## **ROLLING MEADOWS ESTATES**

### **PHASE TWO**

APPLICANT Rolling Meadows Estates Subdivision, Phase 2

REQUEST Subdivision

# DETAIL SITE PLAN

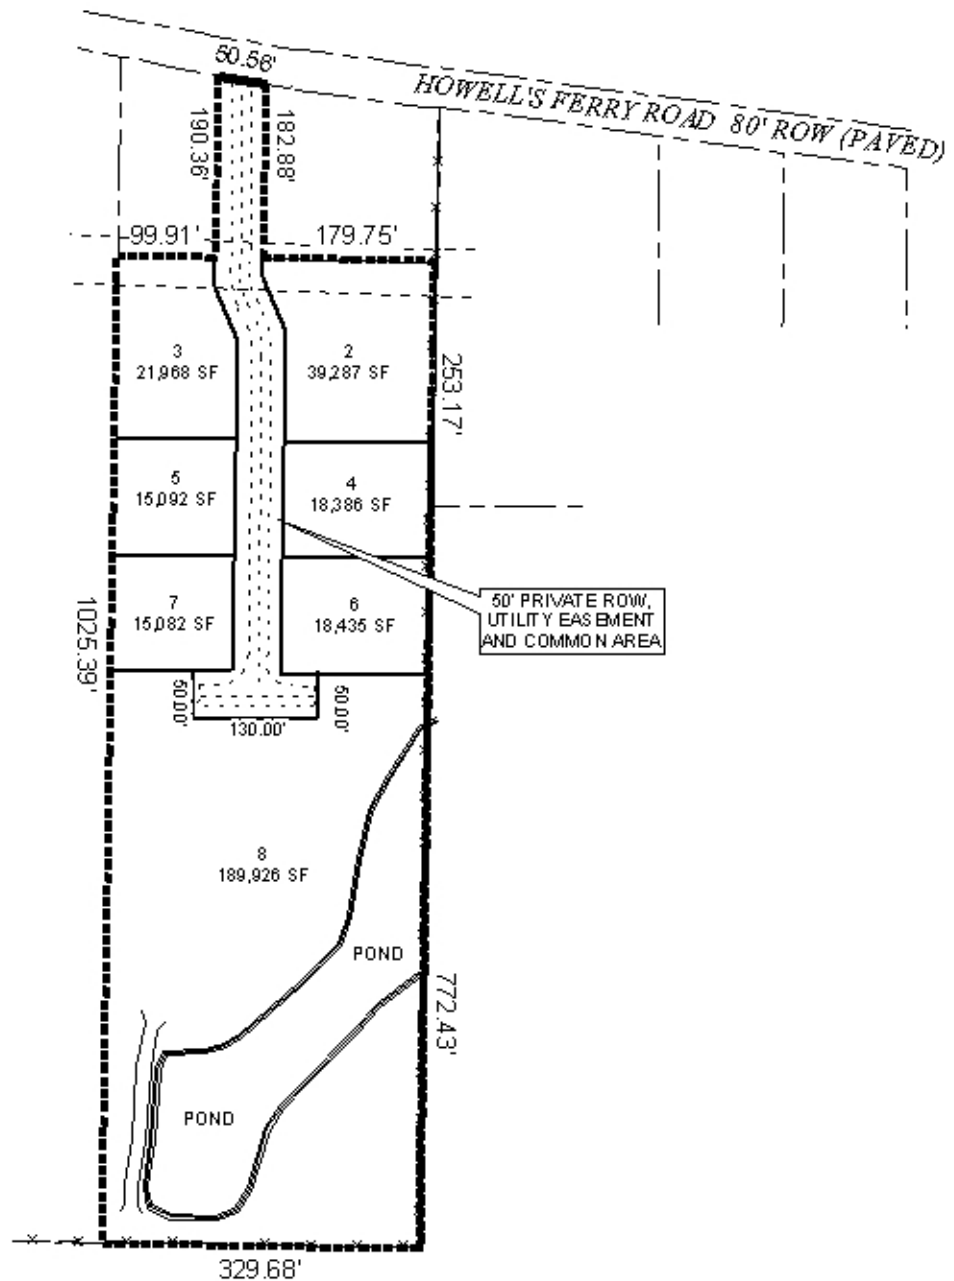
The plat illustrates the proposed 7.9± acre, 7 lot subdivision, which is located on the South side of Howells Ferry Road, 635'± East of the South terminus of Harvey Hill Road – within the planning jurisdiction. The applicant states that the site is served by public water and individual septic tanks.

The applicant is proposing to construct a new 50' wide private street (labeled as *right-of-way, utility easement and common area*) directly accessible from Howells Ferry Road. It should be noted that Section VIII of the Subdivision Regulations permits modifications to standard regulatory requirements under three circumstances: 1) Unusual difficulties, generally related to natural circumstances, where the normal application of the Regulations would cause undue hardship; 2) Innovative design, which can include cluster or Traditional Neighborhood Development subdivisions, as well as town-homes, terrace houses, multi-family projects, and commercial development; or 3) family subdivisions, which allow a private street to serve up to 5 lots. The applicant has not submitted any information justifying the approval of a private street. If approved, however, full compliance with Section VIII.E of the Subdivision Regulations will be required regarding the private street.

It should be noted that the proposed street exceeds 600' in length, the maximum allowed for closed end streets per Section V.B.6 of the Subdivision Regulations; 620' is proposed. Given the previous concerns already mention, staff cannot find any justification in favoring the request. Furthermore, the applicant has not illustrated appropriate radii at the intersection of the private street with Howells Ferry Road. Typically, in order to comply with Section V.B.16 of the Subdivision Regulations, it would appear that properties on either side of the proposed street

would need to be involved in the subdivision process, so as to dedicate the needed right-of-way. However, since private streets enjoy an 18' pavement width, ample space should exist to provide the radii, if approved.

As proposed, each lot has substantial frontage along the private street. If approved and as a means of access management, a note should be placed on the final plat stating that each lot is limited to one curb cut to the private street, with the size, location, and design to be approved by County Engineering and in conformance with AASHTO standards.

Based on the preceding, it is recommended that this application be denied because the applicant did not submit any information justifying the request for a private street and it does not comply with Section V.B.6 of the Subdivision Regulations.
